CODE CHANGE PROPOSAL FORM

Date: 12/30/2020 Revised 1/26/2021; 2/15/21

ANSI/ASHRAE/IES Standard 90.1-2019

Code or Rule Section: 6.1.1.4 Prohibition of
Conditioning Commercial Parking

**Table C6.4.1
CLIMATIC DATA DESIGN CONDITIONS**

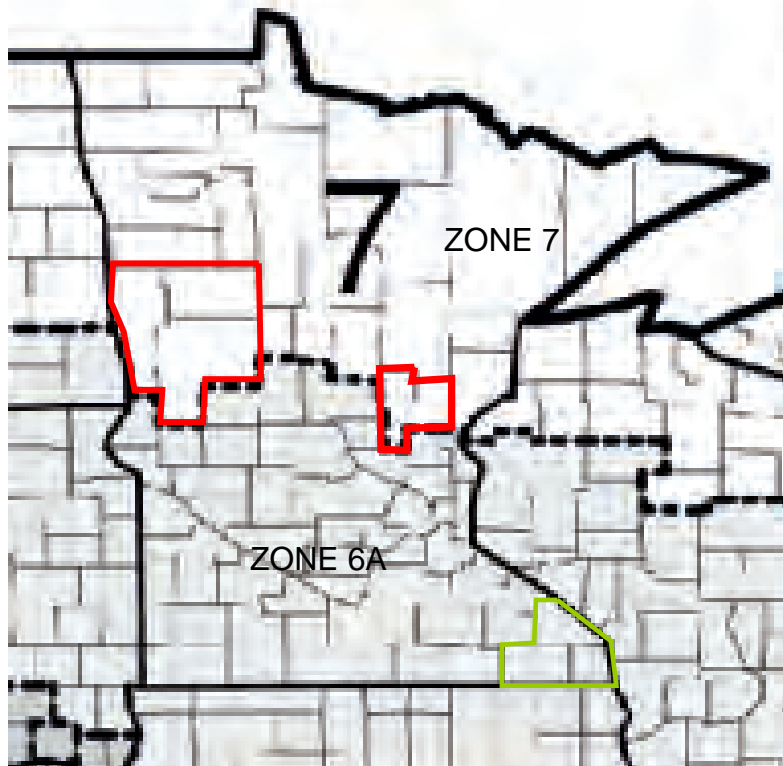
Latest ASHRAE weather based on 8760 hours of the year

2020 Minnesota Energy Code

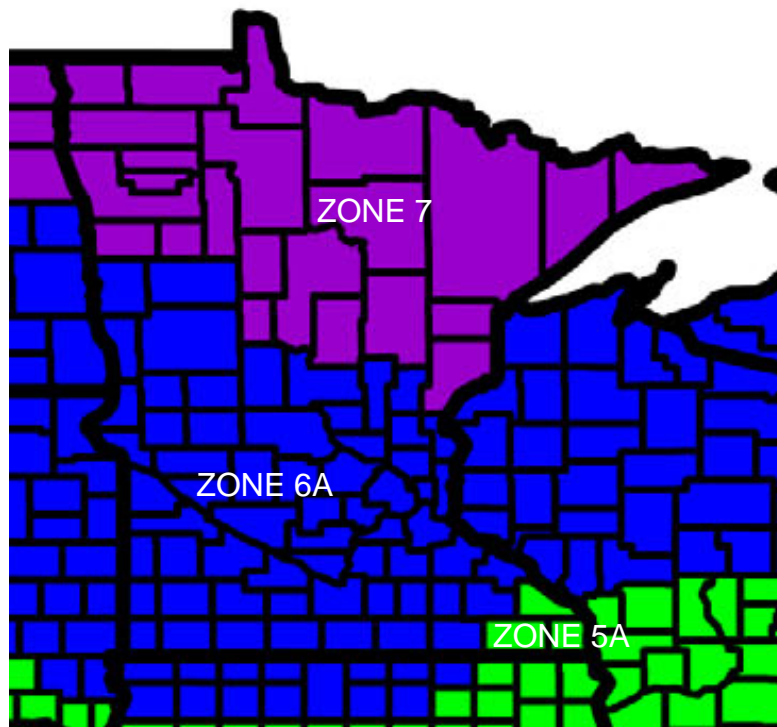
ZONE 7 -> 6A

- Becker
- Clay
- Grant
- Kanabec
- Mile Lacs
- Otter Tail
- Wilkin
